Technical Bulletin

Bulletin No.: TCH-003-025 Effective Date: 4/15/84 Page: 1 of 2

Subject: E-10 Brake Valve #101270 Modification Kit #265073

FIGURE 1

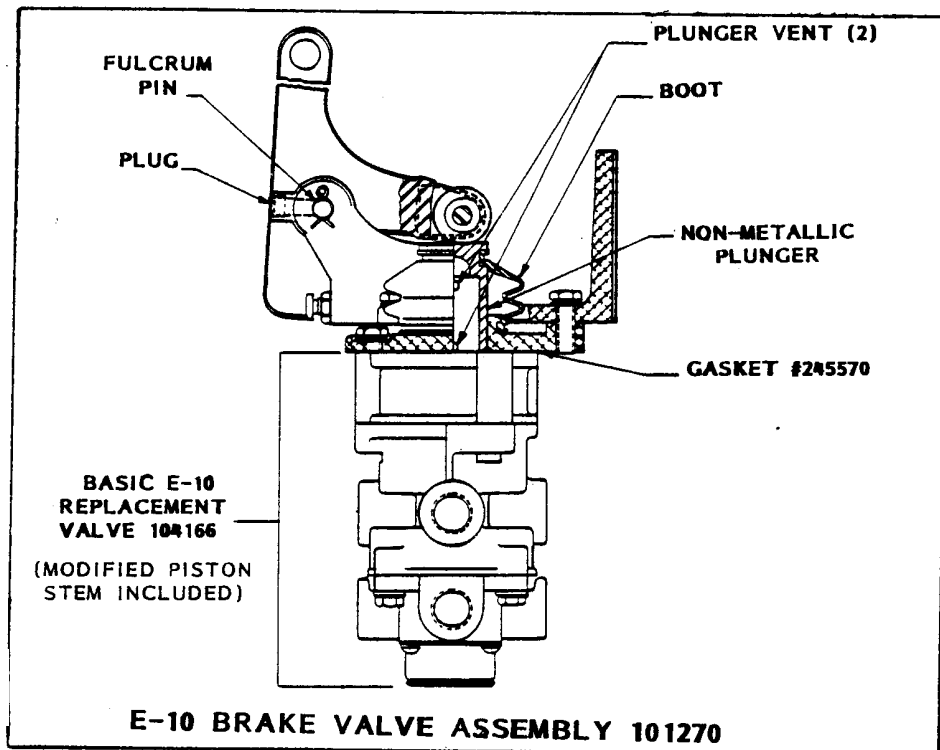
It has come to our attention that the remote mounted E-10 Brake Valve assembly 101270 as installed on M.C.I. and T.M.C. coaches is more susceptible to contamination and internal corrosion due to one or more of the following;

1. Plunger boot deterioration and wear caused by over lubrication of the actuator mechanism.
2. Insufficient sealing between the plunger, boot and mounting plate as well as between the mounting plate and valve body.
3. Contamination entering the brake valve (primarily water and road salt) due to the pumping action of the plunger and boot during application and release.

A number of changes have been made to assembly 101270 to improve its resistance to contamination and internal corrosion on the M.C.I. and T.M.C. installation. (Reference Figure 1)

1. A stainless steel fulcrum pin replaces the standard pin. Factory lubrication of the bell crank and mounting bracket assembly permits the removal of the bell crank grease fitting and eliminates the need for periodic lubrication.
2. A bellows type boot replaces the standard E-10 boot. The bellows boot reduces chaffing and provides improved sealing between the plunger and mounting plate. The addition of a gasket (245570) between the valve body and mounting plate further improves overall valve sealing.
3. A special non-metallic internally vented plunger and a modified primary piston stem permits venting of the boot cavity into the brake valve exhaust. The piston and boot cavities are maintained at or very near atmospheric pressure eliminating the pumping action.

All 101270 brake valve assemblies built after December 21, 1983 incorporate these changes. The bellows style boot provides visual identification of current 101270 E-10 Brake Valve assemblies.

Existing 101270 assemblies can be changed to current revision using modification kit 265073. When installing modification kit 265073, we strongly recommend that maintenance kit 102100 also be installed.
